11-AFC-1

**Re: Pio Pico Energy Center Project (11-AFC-01)
Correspondence to USEPA, Region 9**

Subject: Pio Pico Energy Center PSD Permit Application

Figure 1. Five-Year Averages of 98th Percentile Maximum Daily One-hour NO₂ Concentrations (Measured Background plus Modeled Project and Nearby Sources)

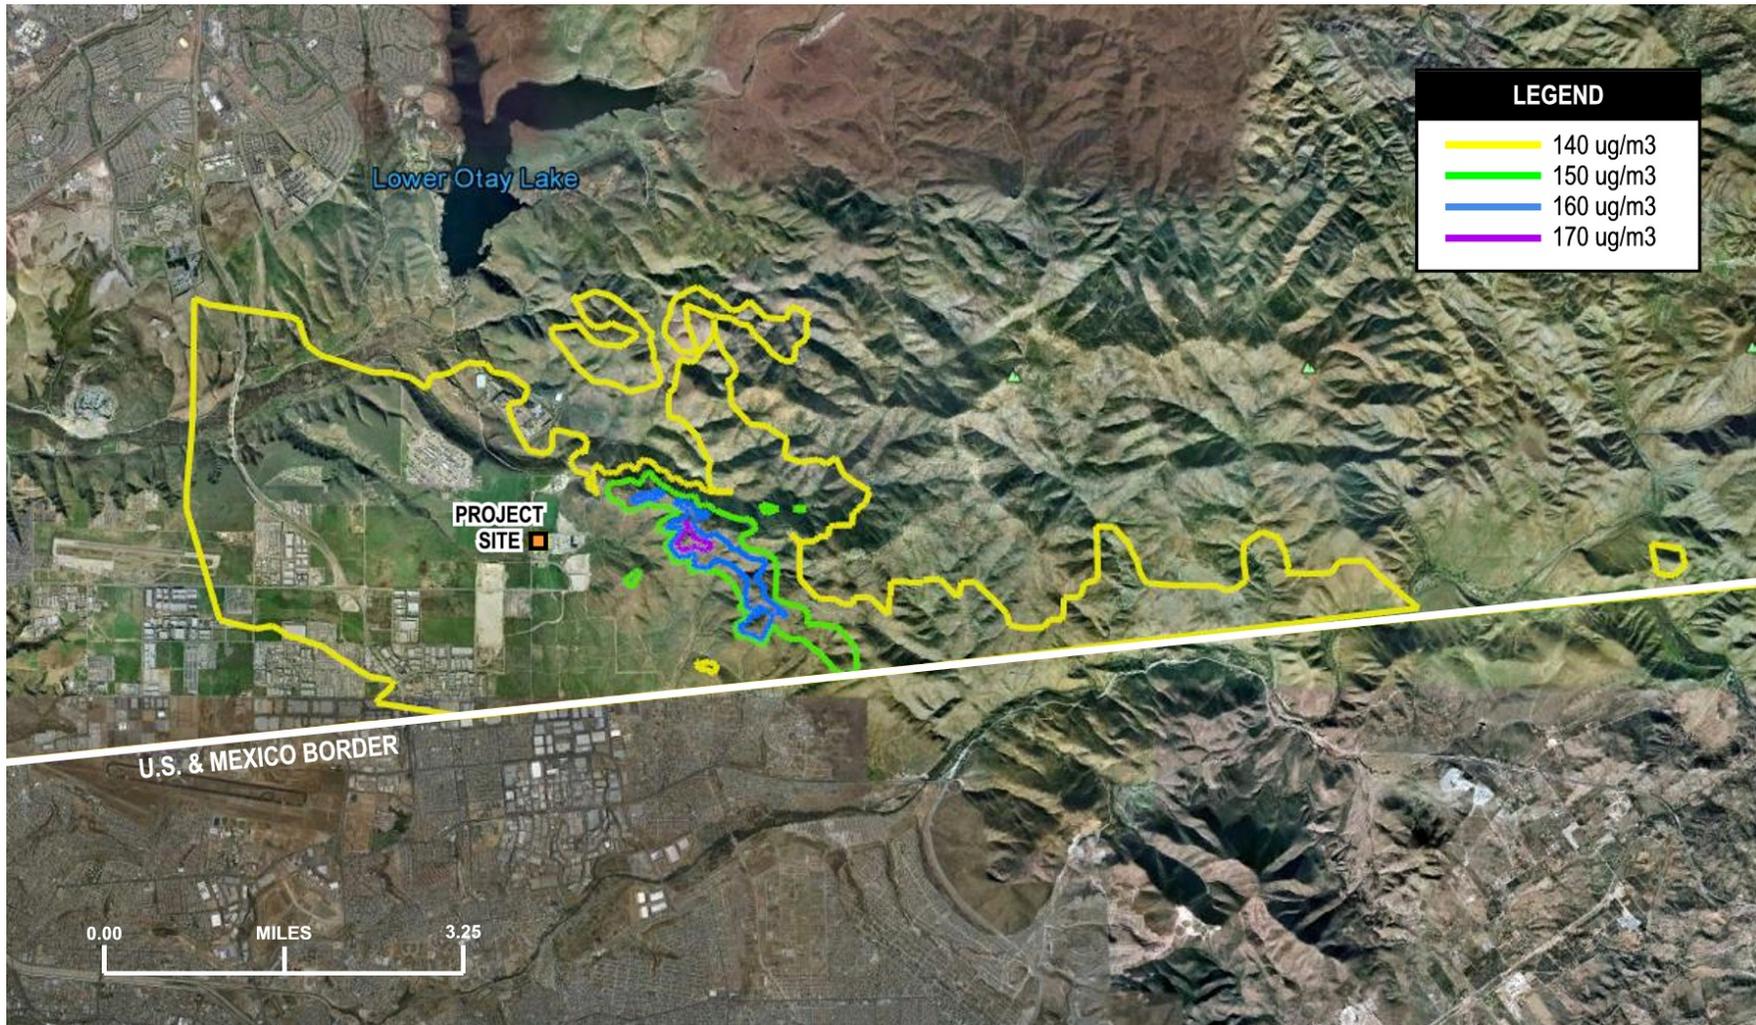
Comment: Please provide isopleths maps showing the 5-year averages of 98th percentile concentrations for both PM_{2.5} and NO₂.

Response: The requested isopleths maps are provided as Figures 1 and 2.

Figure 3. Otay Mesa Meteorological Station and Surrounding Area

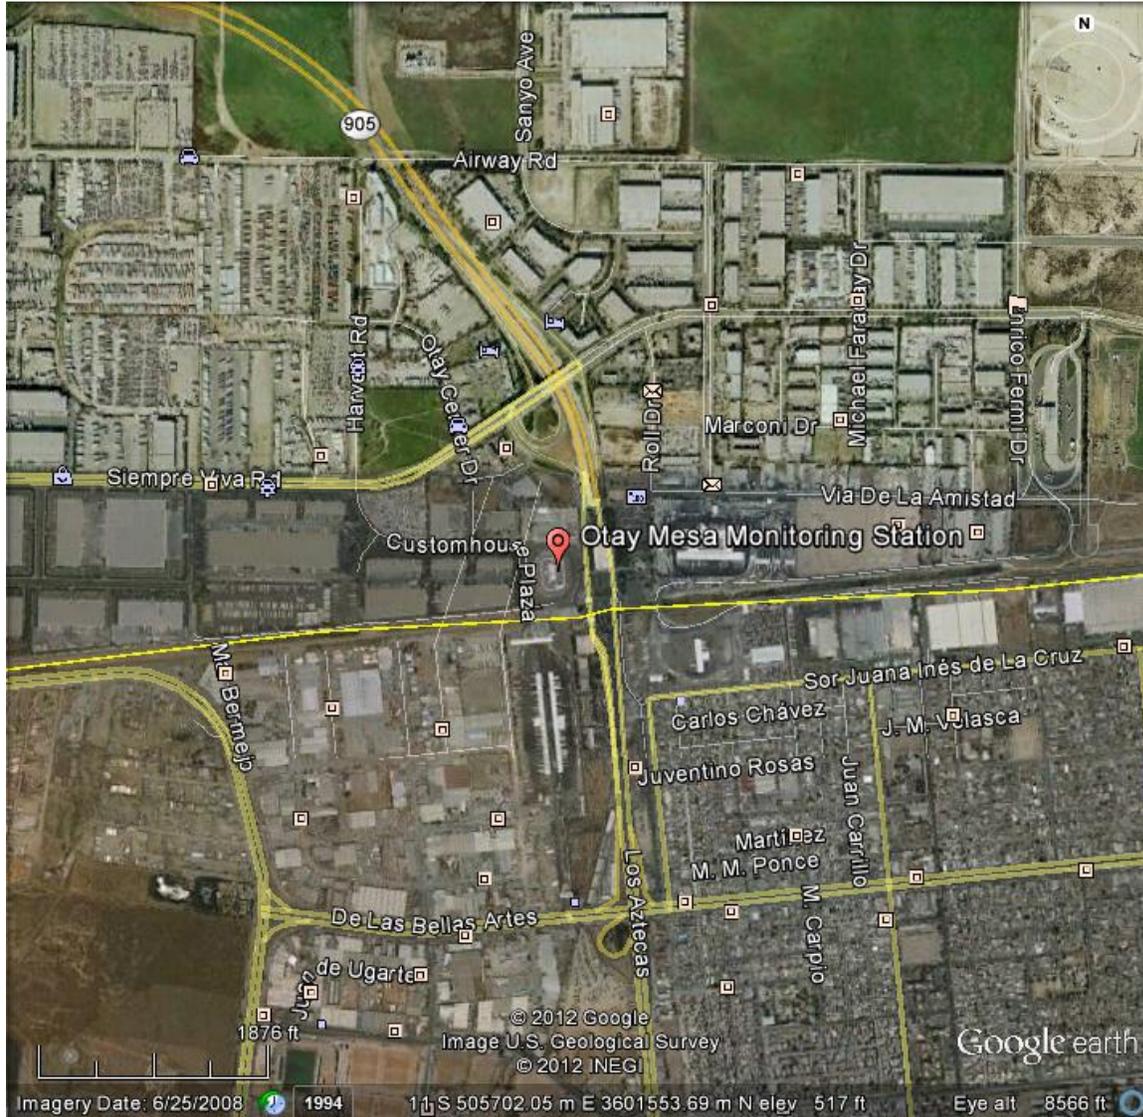
Please provide a more detailed (by sector) comparison of the surface roughness at the project site with the surface roughness at the site providing the meteorological data.

Response: The surface roughness values used in the PPEC PSD permit application were developed by the SDAPCD, and represent the surface roughness surrounding the site where meteorological data were collected. The District followed EPA's "AERMOD Implementation Guide" (2008 version) in using EPA's AERSURFACE processor with the National Land Cover Data 1992 archive to determine surface characteristics for AERMET (Class II Modeling Protocol pp.2-9 to 2-14).

AERSURFACE uses a Land Use data base from 1992, and does not take buildings into account. The District reviewed aerial photos for the area, which show that the vicinity of the Otay Mesa meteorological tower is surrounded by a light industrial and residential area that includes northern Mexico and the U.S border area. Using this information, the District adjusted the surface roughness factor from the value of approximately 0.2 meters calculated by AERSURFACE to 0.7 meters to more accurately represent the current terrain and structures surrounding the Otay Mesa meteorological monitoring station location (see Figure 3). The District's adjustment is supported by AERSURFACE guidance¹¹ and the scientific literature.¹² EPA's AERSURFACE guidance assigns an even higher surface roughness of 0.8 m to commercial/industrial/transportation areas (Class 23) not located at an airport. Stull's scientific textbook on boundary layer meteorology, which is a scientific reference for Table A-3 in EPA's AERSURFACE User's Guide, gives a surface roughness range of approximately 0.7 m to 1.3 m for "Centers of large towns and cities."

SDAPCD performed a qualitative review of the surface roughness values used by the Applicant (per instructions by the District) to ensure that they were reasonably representative of the project site. It did this by examining the 10 km by 10 km domain centered on the project site, and determined that the data in the two tables are reasonably representative of the domain as a whole. This conclusion is not surprising, because both locations are located within that 10 km by 10 km domain.
